**ADDENDUM NO. 2
TO CONTRACT DOCUMENT PLANS SPECIFICATIONS**

**PROJECT: MWA METRO PARK WEST LANDFILL
P-67 CELL E LINER, LEACHATE LAGOON, AND SED POND**
TO: PROSPECTIVE BIDDERS AND OTHER INTERESTED PARTIES

SHEET: C506

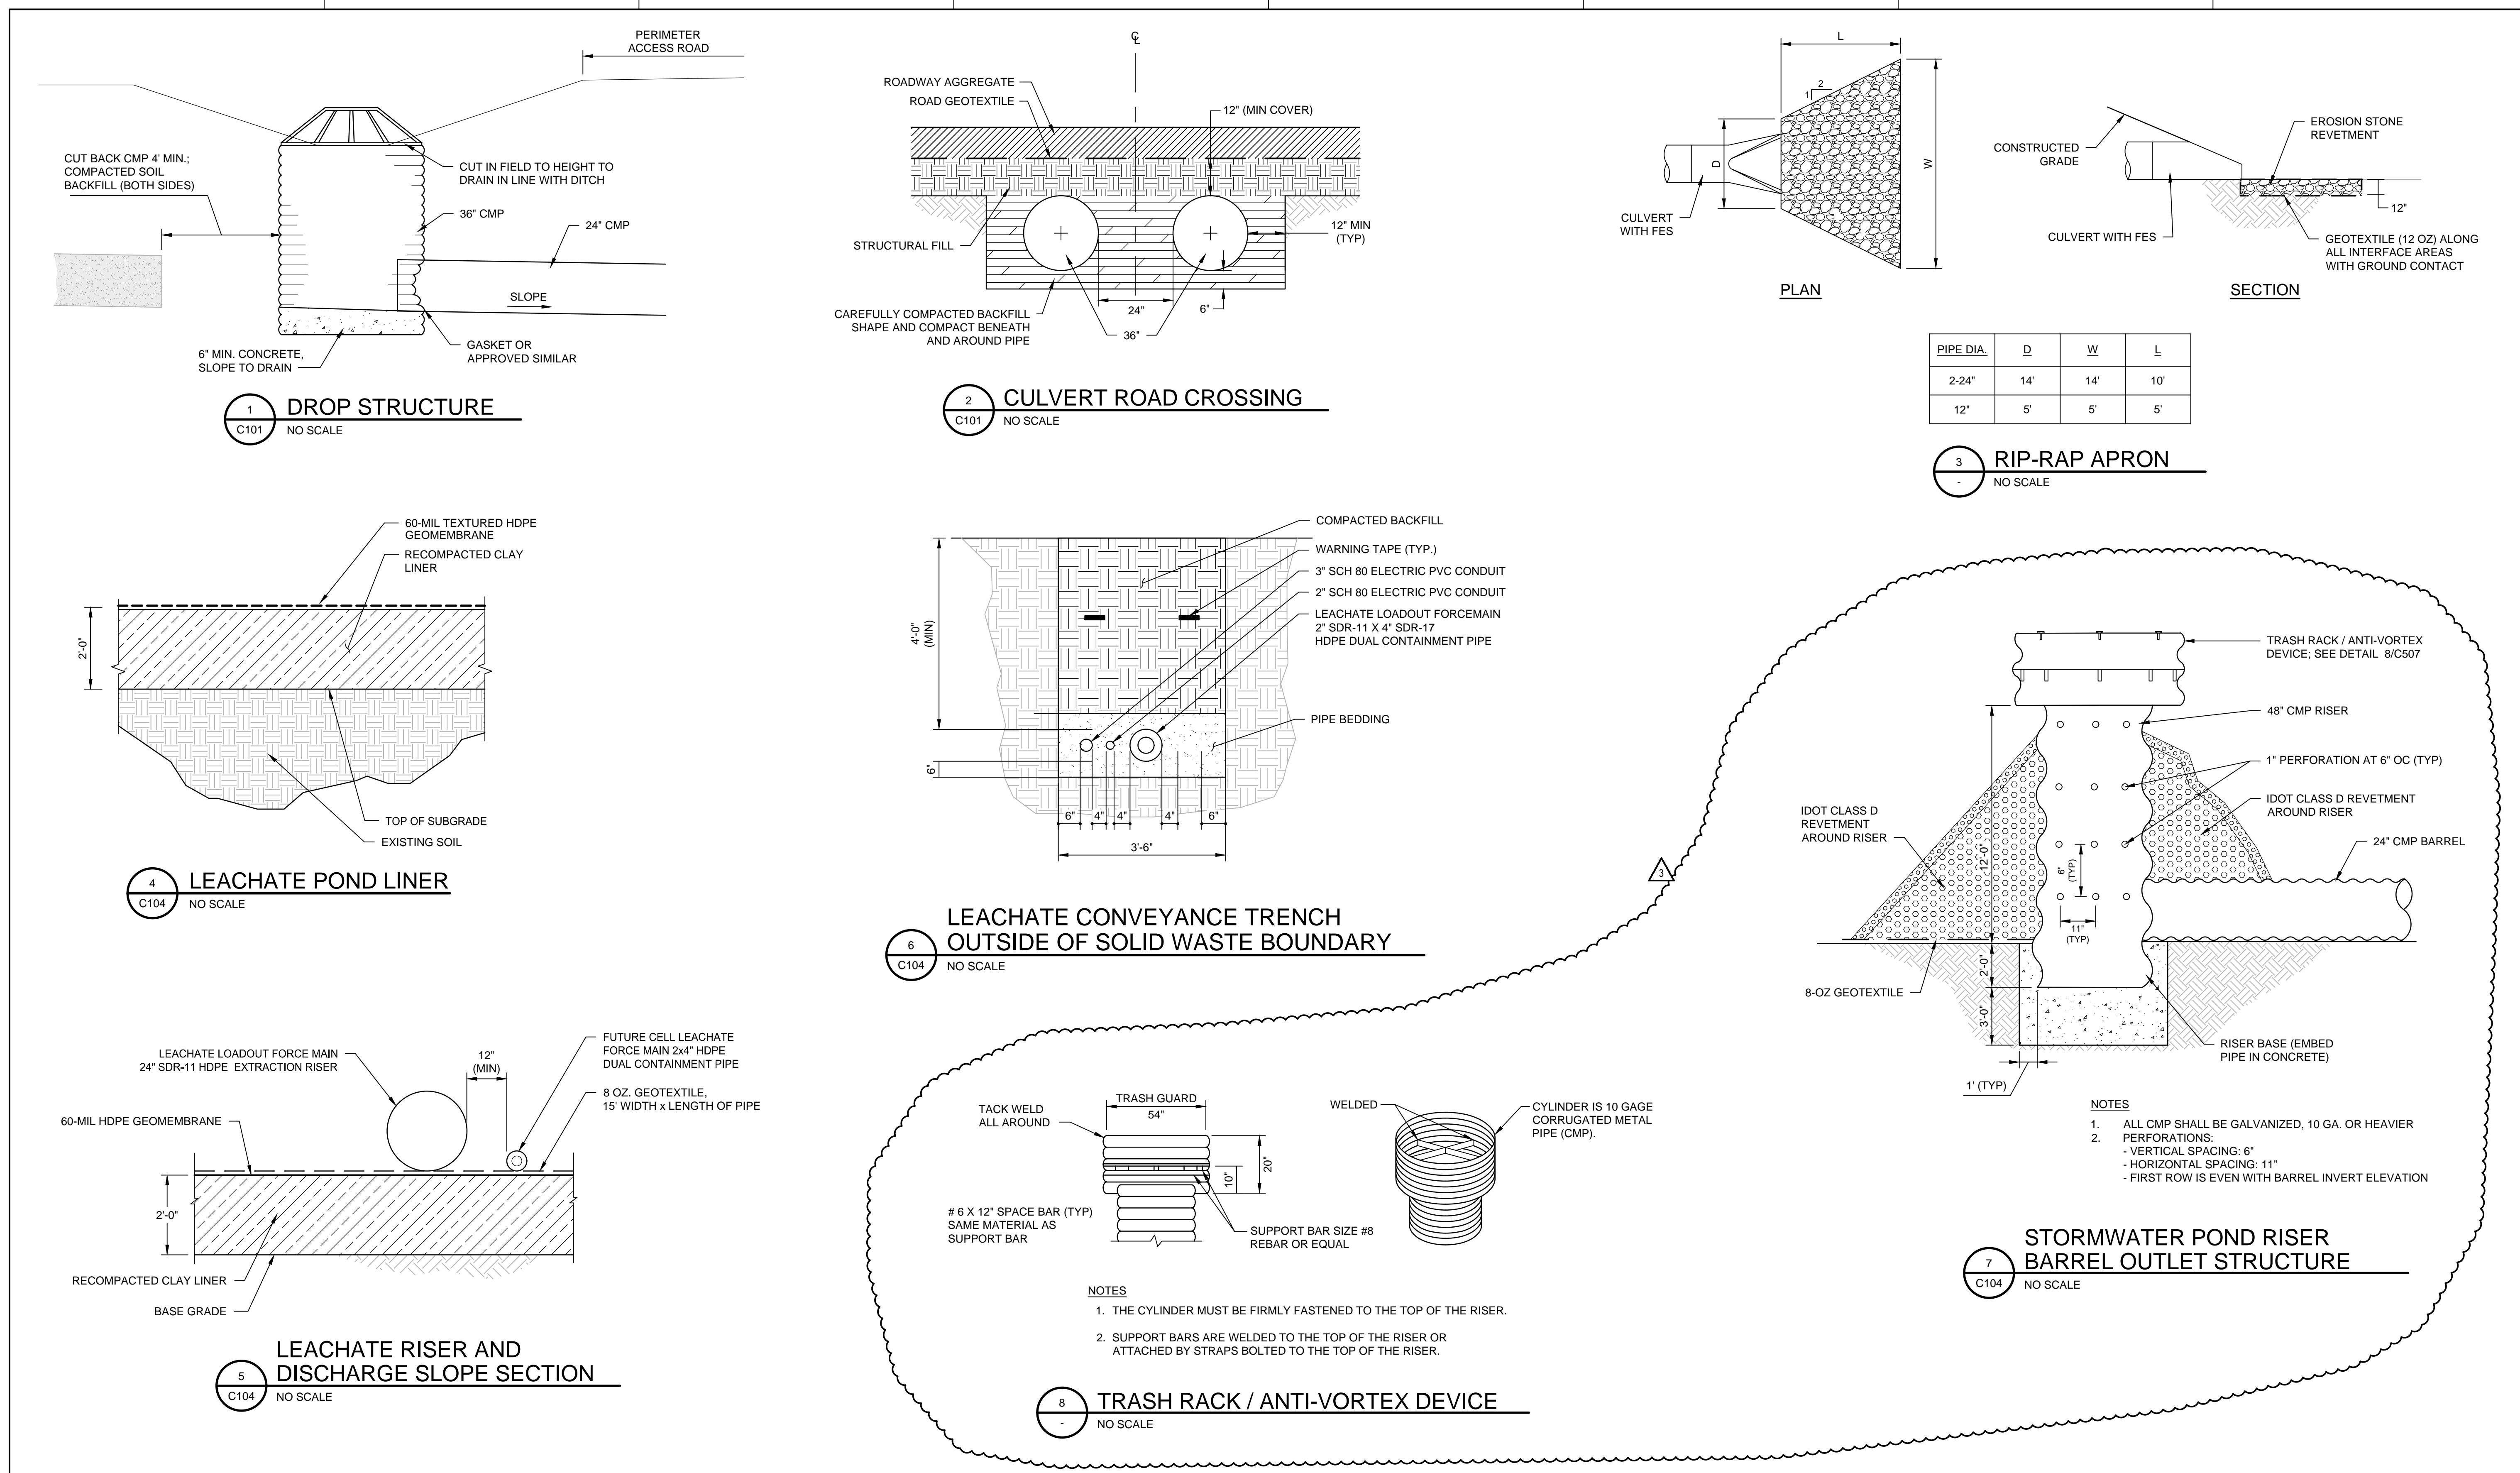
Question 14: Can you please provide groundwater control trench elevations per the note on sheet C506 that slows for positive drainage of the GWT pipe? Can you provide a detail of the GWT cleanout riser?

Answer 14: Please see updated groundwater control trench detail on Sheet C506 and updated drawing Sheet C505 for additional GWT cleanout riser details on the Leachate Extraction Headwall detail.
